Supplemental Columbia River Protection Activities at the Department of Energy Hanford Site: 2006 Technical Peer Review

Prepared for
Department of Energy Office of Clean-up Technology, EM-21
Washington, D.C.

December 2006

Figure 1 Conceptual model used for calculations in review.

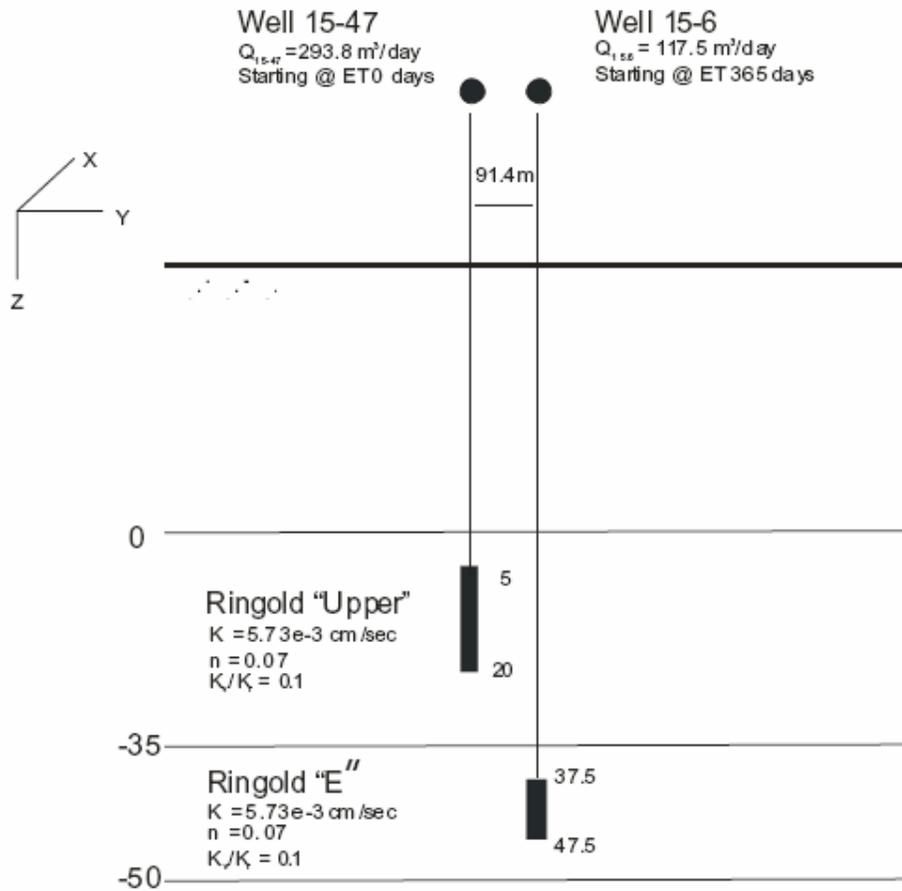
for the design of this test. The reviewer had to make several assumptions regarding the 2D model based on visual inspection of Figure 1 in the proposal: 1) FEFLOW was used to simulate a *vertical* slice of the contaminated aquifer 2) could not determine condition used for top boundary 3) constant head used for side boundaries (ends) 4) no flow boundary used for the bottom. The combination of conditions 1 and 3 greatly constrain the solution and do not account for radial flow towards the well out of the plane of the slice as a result most of the water is forced to come through the ends of the model.

An alternative flow model was prepared using information in the proposal and available in the resource packet provided with the proposal. The model used the Neuman (1974) solution for a pumping test in an unconfined aquifer with correction for partially penetrating wells and the principle of superposition to account for multiple pumping wells. The attached figures show the conceptual model (Figure 1) and results (Figure 2 - 4). Figure 2 shows time drawdown curves for *hypothetical observation wells* located in the lower "E" zone of the unconfined aquifer next to the 2 pumping wells used in the study. Well 15-47 is operated 365 days before well 15-6 is turned on for the 90 day test.

Figure 3 Drawdown map and cross section for pumping test.

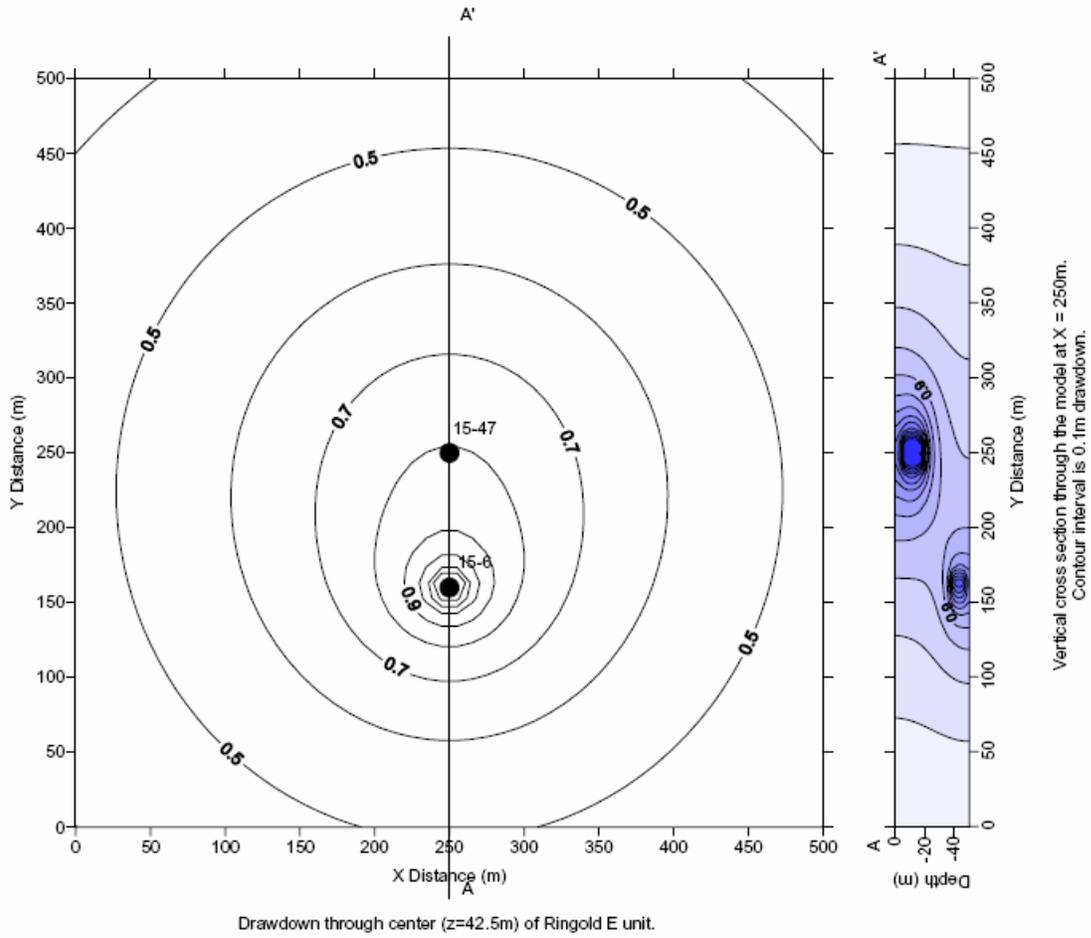
(Figure 3) indicates that the capture zone for well 15-47 may extend from the water table surface to the base of the aquifer between the 2 groundwater wells. Well 15-47 is located between trench 216-Z-9 and well 15-6 and regional groundwater flow ~ perpendicular to a line that connects. Figure 4 shows the simulated hydraulic head for the center of the lower "E" unit of the unconfined aquifer. The assumed natural (no pumping) gradient for the test area was taken to be 0.001 parallel to the x axis based on the water table in ref2. Figures 3 and 4 illustrate the complex 3 dimensional flow field for a multi-well pumping test in an anisotropic aquifer with a non zero natural gradient. The additional pumping wells and injection wells in the actual test area will only make the actual flow field more complex.

Figure 4 Hydraulic head map for the center ($z = 42.5\text{m}$) Ringold “E” unit.

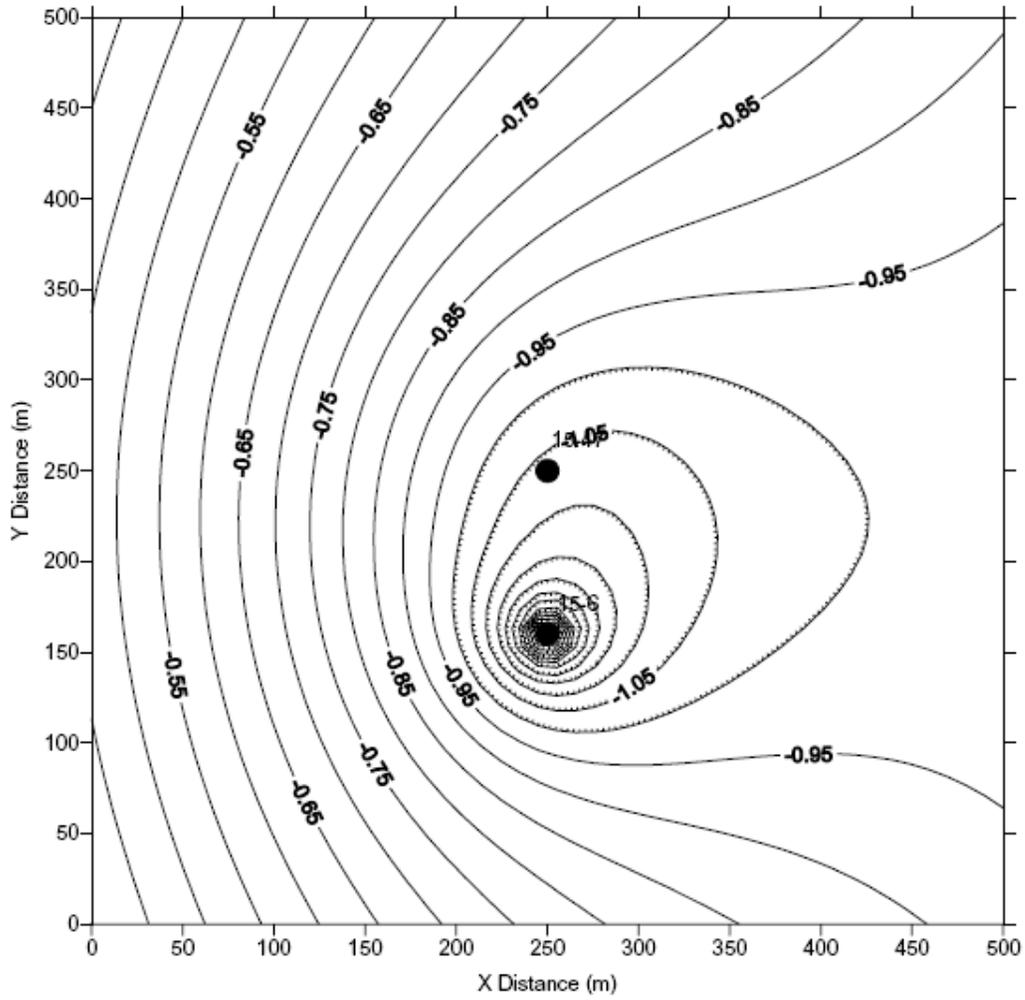
Use of particle tracking with a 3D model of groundwater flow would provide useful information about whether or not well 15-6 would capture groundwater at the base of the unconfined aquifer beneath trench 216-Z-9 and if so how long it might take a packet of water to travel there. CCl₄ concentrations above 8 mg/L can be considered an indicator of DNAPL presence.
